SERVICE BULLETIN

OIL - PROVIDE AN OIL TANK SIGHT GLASS OIL LEVEL INDICATOR - CATEGORY CODE 8 -
MOD.ENG-79-0025

V2500-ENG-79-0025

Oil tank assembly before alteration
Fig.1

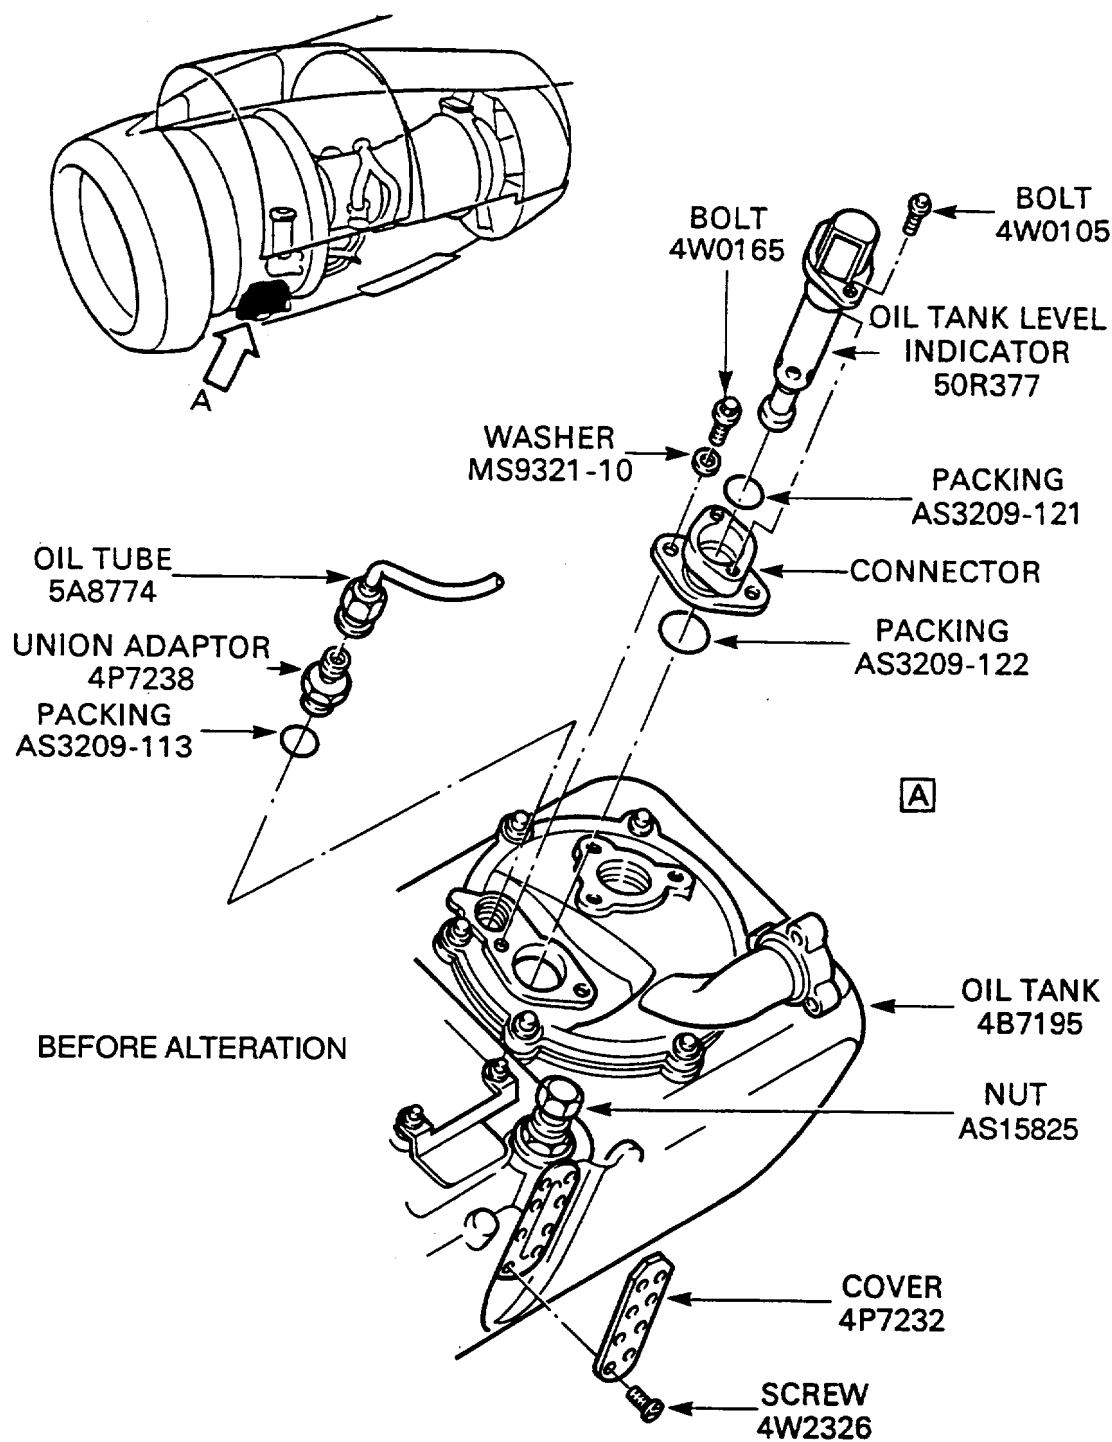
- (1) The changes introduced by this Service Bulletin are as follows: See Figure 3.
 - (a) The existing oil tank level indicator has been deleted.
 - (b) A sight glass has been added
 - (c) The oil spill tube has been modified in its course in order to use the spill flow for keeping the sight glass clean.
 - (d) The new spill tube is secured to the oil tank by an added bracket.
- (2) This Service Bulletin must be incorporated concurrently with or subsequent to Service Bulletin V2500-ENG-71-0110

Rework the Oil Tank
Fig.2

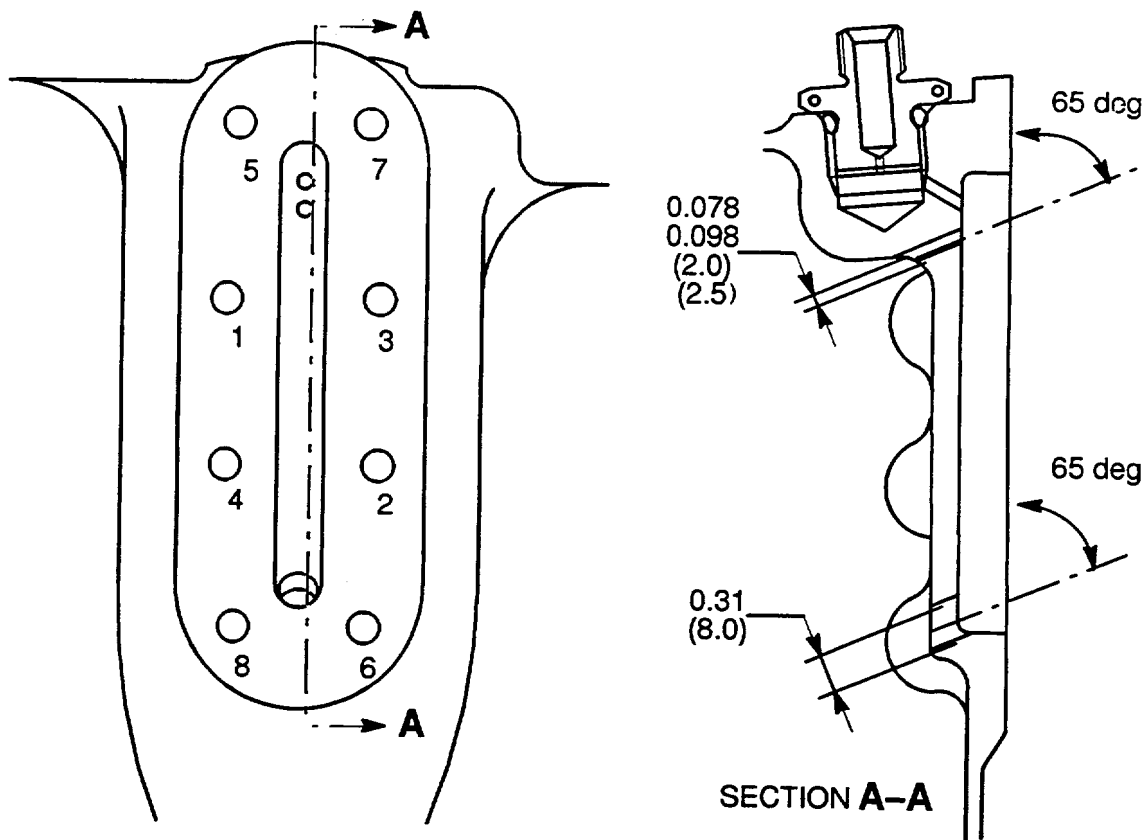
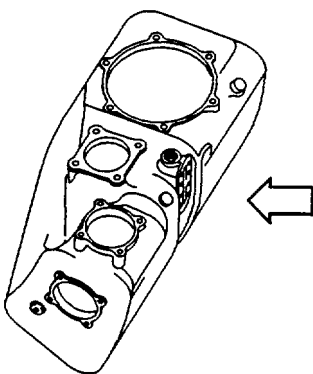
- (1) Rework 4B7195 Oil Tank and reidentify as follows. See Figure 2.

Procedure	Supplementary Information	
(a) Install the IAE3F10441 drill mask on the oil tank and secure with screws.	See figure 2	
(b) Make two holes as required.	See figure 2 Use a suitable drill	
(c) Remove the mask		
(D) Remove the burrs around the holes.	Use an hand pneumatic grinder.	
(e) Clean the internal surfaces of the oil tank from the debris.	Use suitable vacuum cleaner.	
(f) Renumber 4B7244 adjacent to existing Part Number. Delete 4B7195 with a single line.	Use marking pencil, vibrating. Refer to SPM TASK 70-09-00-400-501.	
	Existing	Renumber
	4B7195	4B7244

RUN DOWN AND TORQUE THE SCREWS
IN THE SEQUENCE FROM 1 TO 8

Oil tank assembly after alteration
Fig.3

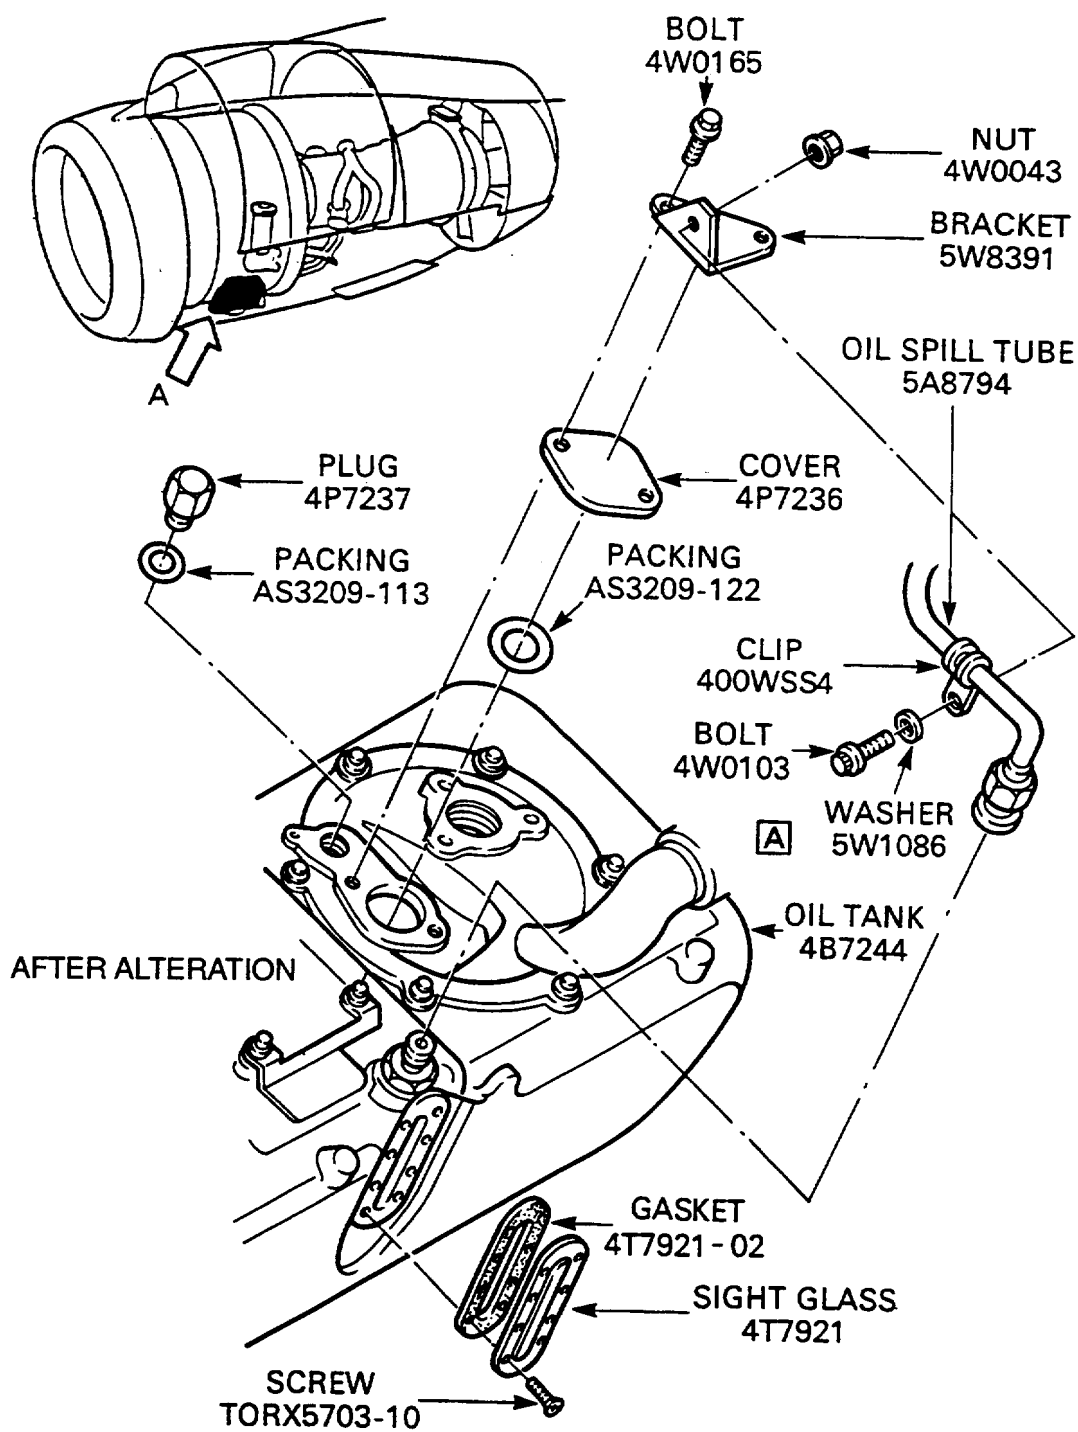
- (1) Assemble the renumbered oil tank as follow. See Figure 3.

- (a) Install the 4T7921 Sight Glass in place of the cover. See Figure 3.

(i) Place the new 4T7921-02 Gasket and the new 4T7921 Sight Glass in position.

(ii) Place TORX5703-10 screws (8 off) in their seats and make sure you engage properly the helicoil.

(iii) Run down the screws in a cross sequence from No. 1 to 8 until they are seated. See Figure 2

(iv) Torque the screws, always in the correct sequence, to between 30.0 and 35.0 lbfin (3,39 to 3,95 Nm).
